## Washington Public Power Supply System

Subject: SUPPLY SYSTEM NUCLEAR PROJECT NO. 3  
ENVIRONMENTAL REPORT - OPERATING LICENSE STAGE  
RESPONSE TO NRC REQUEST FOR INFORMATION

RESPONSES TO NRC QUESTIONS OF JULY 19, 1983 (Re: WNP-3 ER-OL)

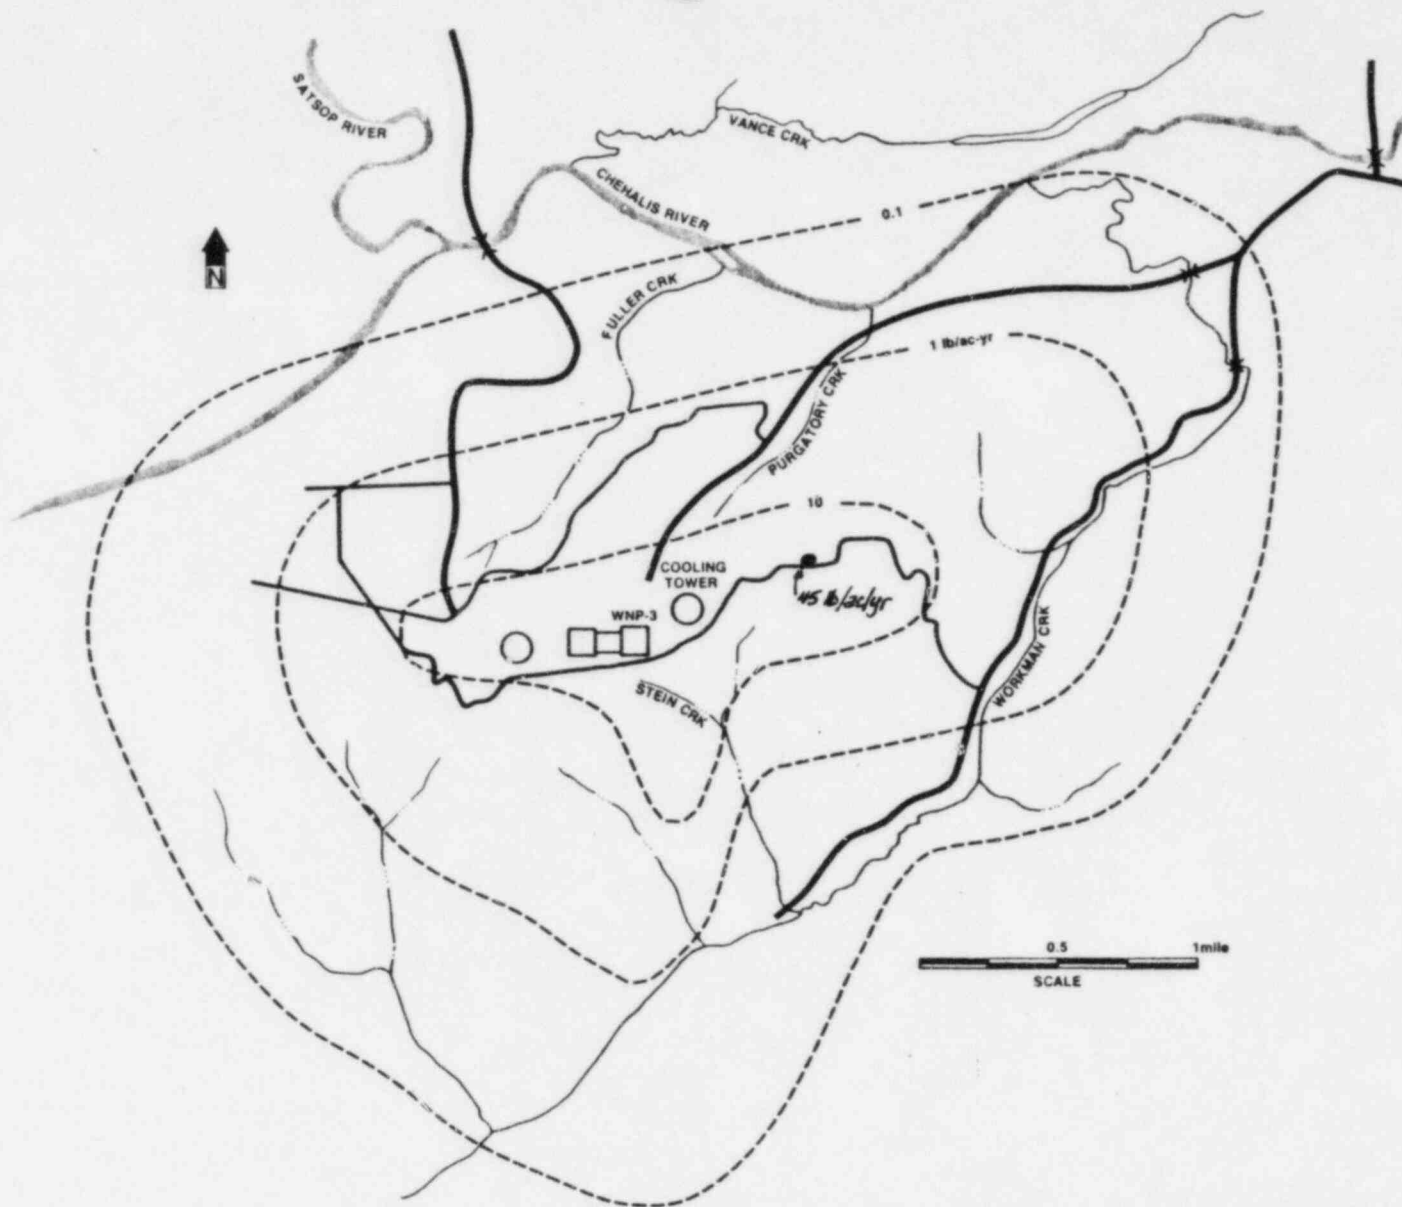
290.15 Q. ER-OL Figure 2.2-2 should have the roads and site boundary indicated. Also the stippled area should not be identified.

A. Figure 2.2-2 has been revised to show roads for reference. The stippled area approximates the plant island construction area which was cleared in site preparation.

WNP-3 COOLING TOWER DRIFT  
(lb/acres/yr)  
Re: Q290.13

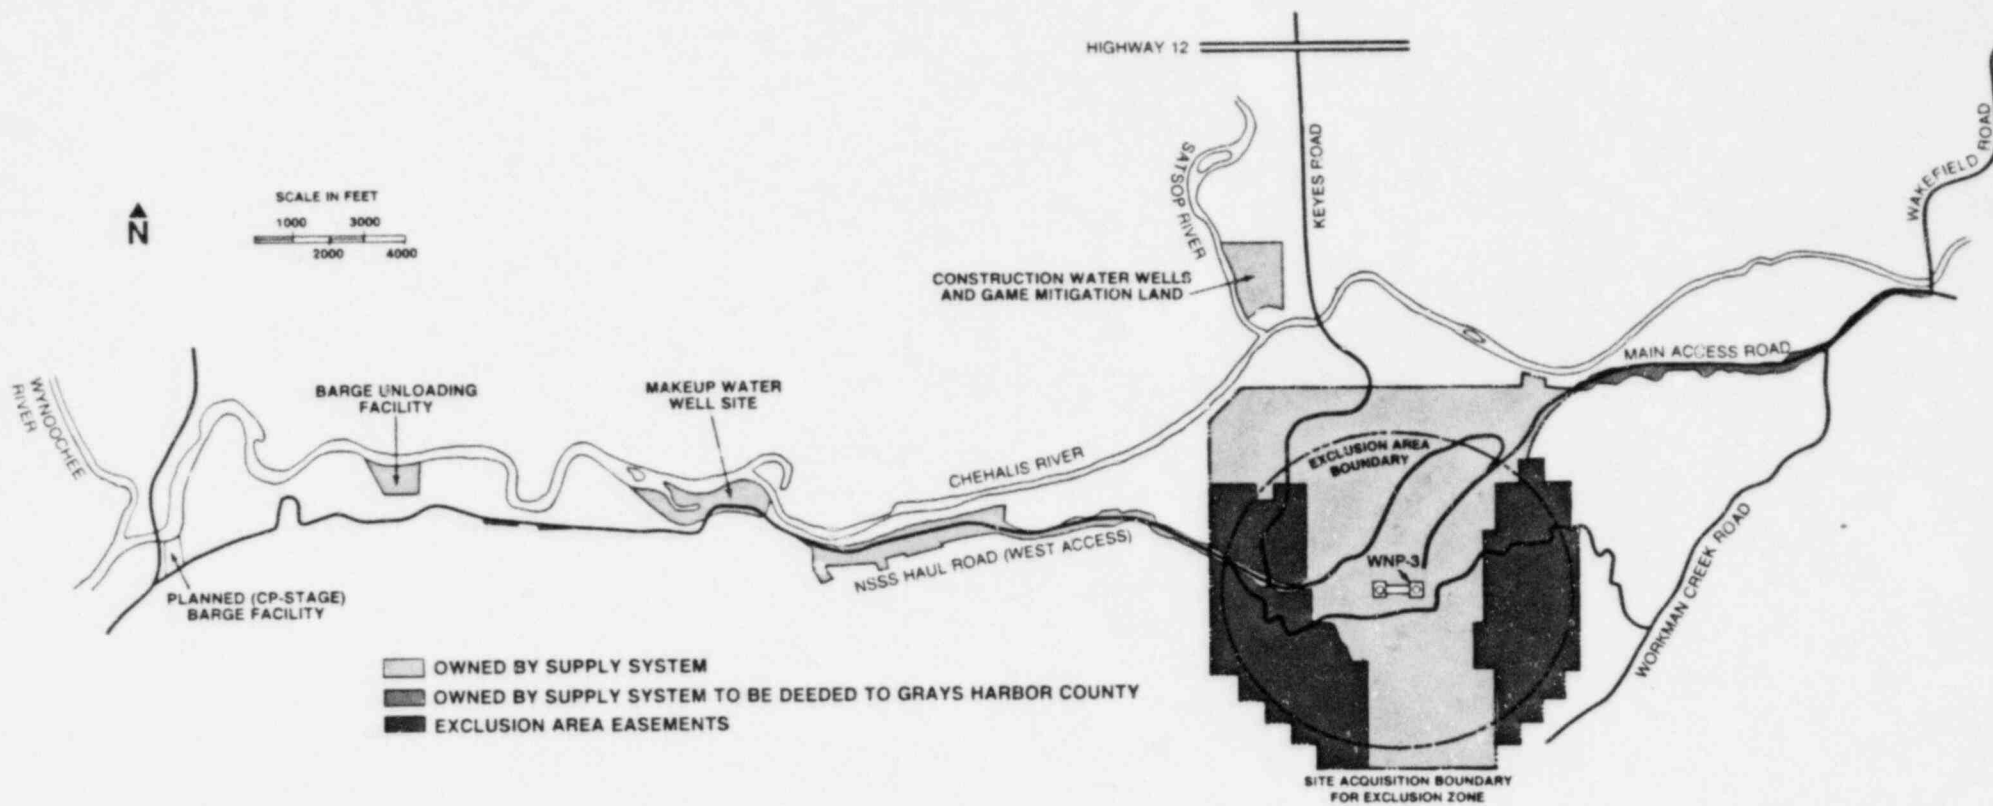
290.13 Q. This question was asked previously (Q290.06). The answer is inadequate. The isopleths provided in Figure 5.1-4 should be superimposed on an aerial photograph or map of the site in order to be able to evaluate which land use will be impacted by the drift. In addition Figure 5.1-4 does not have either an isopleth for 2 lb/acre-yr or any indication of where the 20 lb/acre-yr area is located or where the 45 lb/acre-yr will occur. Please provide.

A. In the attached figure the drift deposition isopleths of Figure 5.1-4 (Amendment 1) are superimposed on a map of the site. Also indicated is the location of where the highest annual deposition (45 lb/acre) beyond 1500 feet from the tower is expected. This figure may be compared with Figure 2.2-1 (discussed in response to Q290.14 below) to compare impacted area with land use.

FIGURE 2.2-1

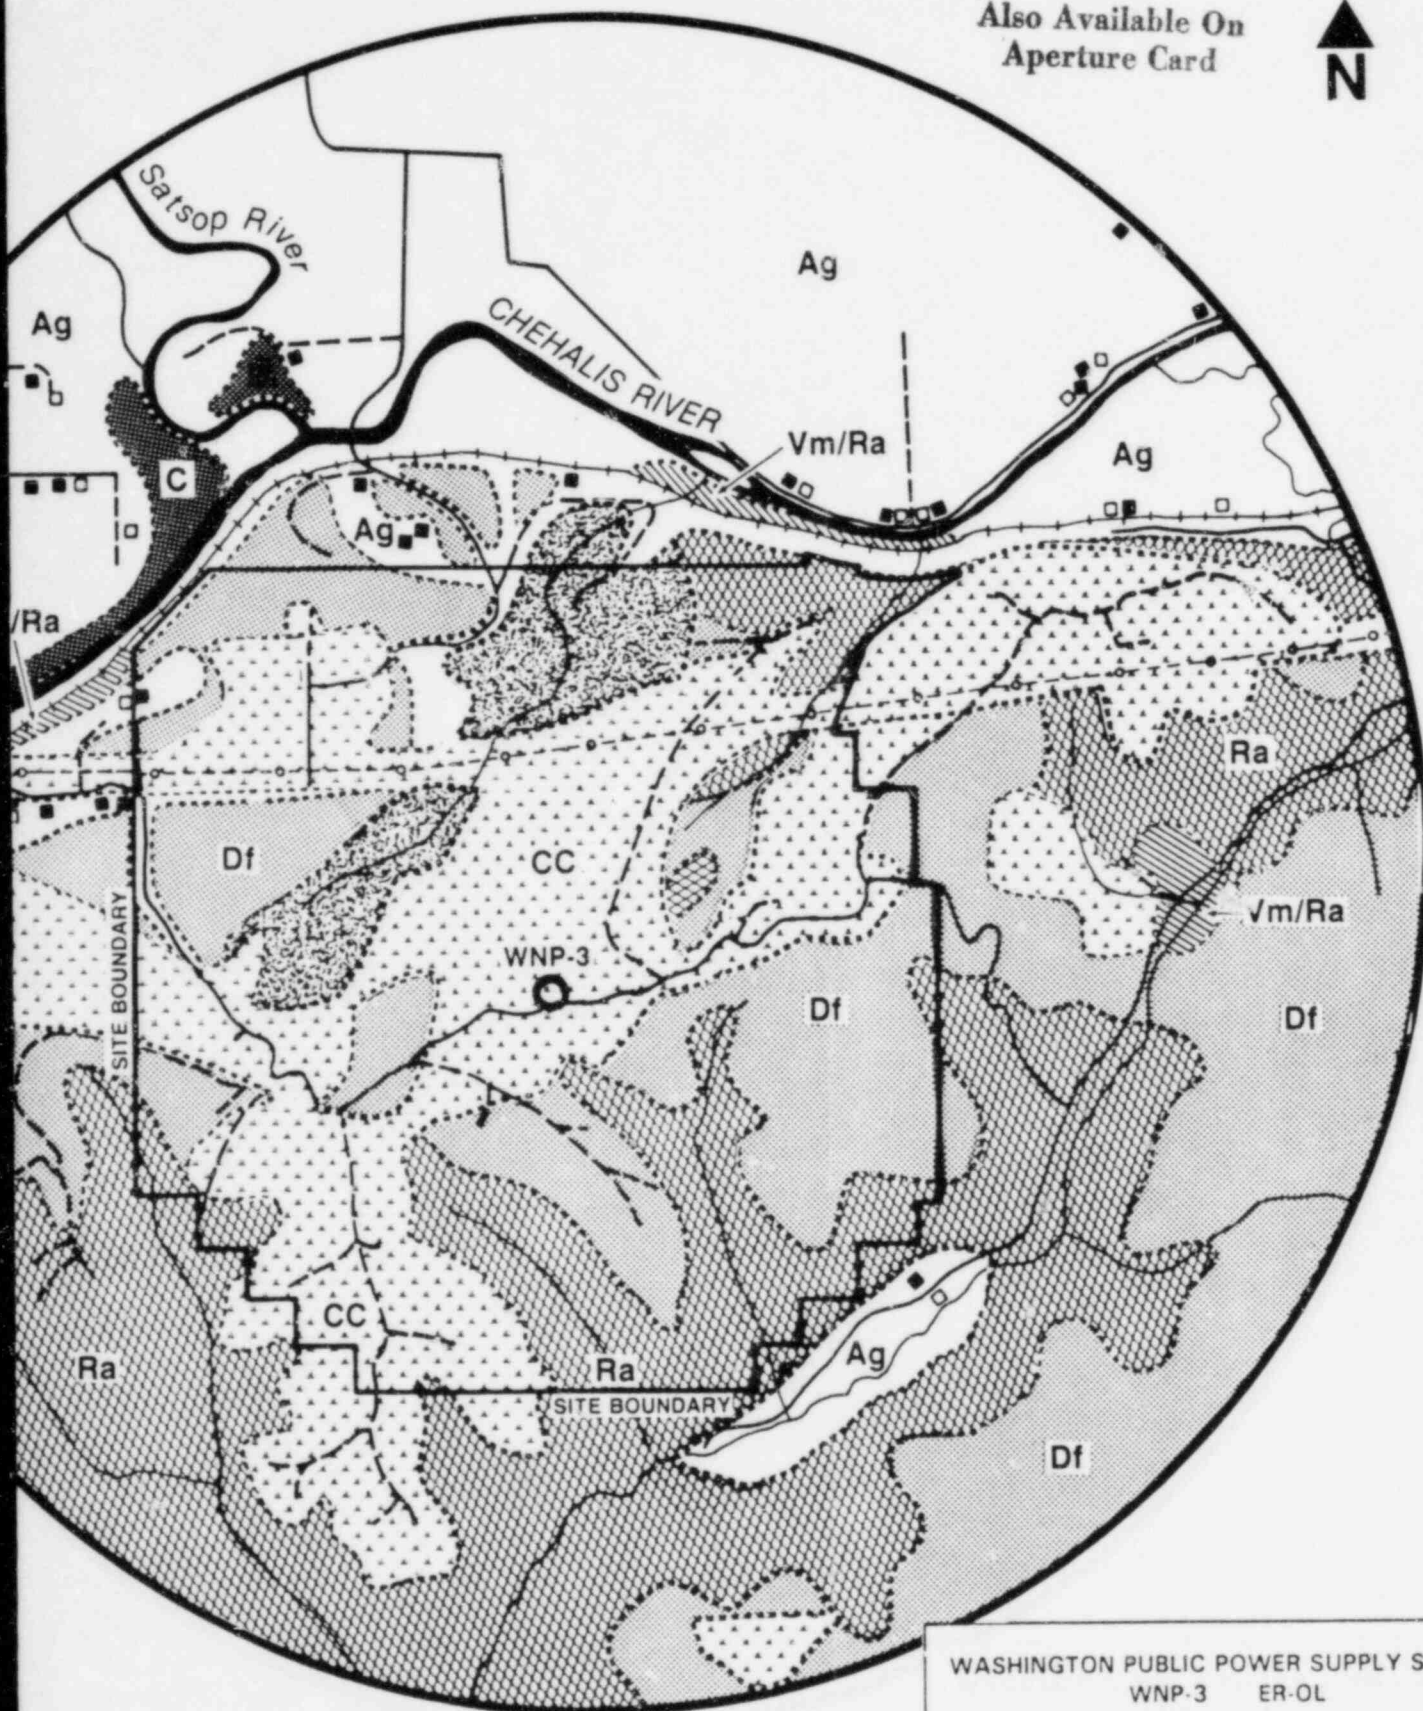
290.14 Q. ER-OL Figure 2.2-1 should have an outline of the site. Page 2.1-1, ER-OL states that land owned by the Supply System in the site proper totals about 1,120 acres. On P. 2.2-1 it states the WNP-3 site is approximately 800 acres. The FES-CP P. 2-1 states that the site encompasses approximately 2,270 acres. To clear up the confusion provide a recent period photograph or map of the site on which is superimposed the current site boundary, the exclusion zone and the site boundary at the CP stage. Provide the number of hectares (acres) contained within these three boundaries.

A. ER-OL Figure 2.1-1 has an outline of the central site area (e.g., site proper) consistent with FES-CP Figure 2.2. When the ER-OL was filed, Supply System ownership in this area totaled 1,120 acres with the remainder (approximately 1,070 acres) under exclusion zone easements. This is consistent with the 2,170 acres cited in the FES at Page 2-1. The total area and the ownership-easement split were altered slightly (to 1,360 acres fee-owned/830 acres easement) in March 1983 with the conclusion of condemnation proceedings on a parcel of land south of the plant. Both the FSAR and ER-OL will be amended to reflect the change. Supply System ownership of land for support facilities (makeup water wells, barge unloading dock, access right-of-way, etc.,) outside the site proper totals about 380 acres. At the CP stage the lands required for access and support facilities outside the central site area were not well defined and it was intended that many of the areas would be under lease or easement agreements. Included with this response is a property map which indicates changes in site area since the CP stage.

Reference to 800 acres on P. 2.2-1 is confusing. It was intended to note the total area affected by construction. It will be clarified by amendment. Figure 2.2-1 has been amended to include the central site outline.
